December 2016
FL727AB
NHTSA #16V-809
SECOND REVISED NOTICE

Subject: FCCC Motorhome Power Steering Hose Routing

Models Affected: Specific Freightliner Custom Chassis XBR, XCL, XCM, and XCR chassis equipped with Cummins ISL engines, and manufactured January 1, 2016, through October 13, 2016.

Fig. 1, Power Steering Hose with P-Clip (body removed for clarity)

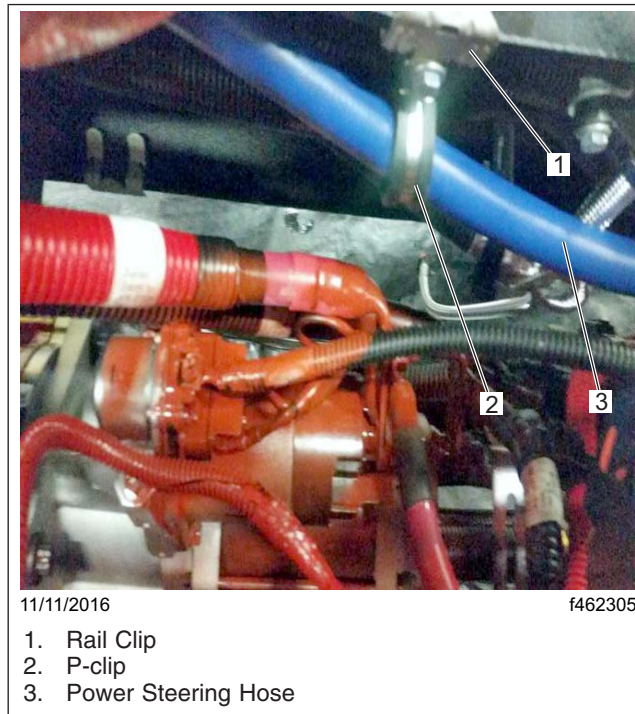
On certain motorhome chassis, the high pressure power steering hose may be routed with inadequate clearance between the hose and a power stud on the starter motor. This may cause the hose to chafe against the power stud on the starter, potentially leading to arcing and, in addition, may cause loss of fluid, short circuit, and melting. Electrical arcing in the presence of leaking power steering fluid can increase the risk of a fire.

The high pressure power steering hoses will be rerouted to provide adequate clearance from the starter stud.

- 6.1 If the power steering hose is held with a P-clip near the starter stud, no work is needed. See [Fig. 1](#). Clean a spot on the base label (Form WAR259). Write the recall number, FL727, on a completion sticker (Form WAR260), and attach it to the base label.

1. Install a rail clip on the top flange of the frame rail, just above the starter.
2. Using a P-clip, bolt, nut, and washer, secure the power steering hose on the rail clip. See [Fig. 1](#). Tighten the nut 72 lbf-in (813 N-cm).
3. For additional security, install tie bands around the hose to the harness near the frame rail within 18 inches (46 cm) of the P-clip.
4. Clean a spot on the base label (Form WAR259). Write the recall number, FL727, on a completion sticker (Form WAR260), and attach it to the base label.
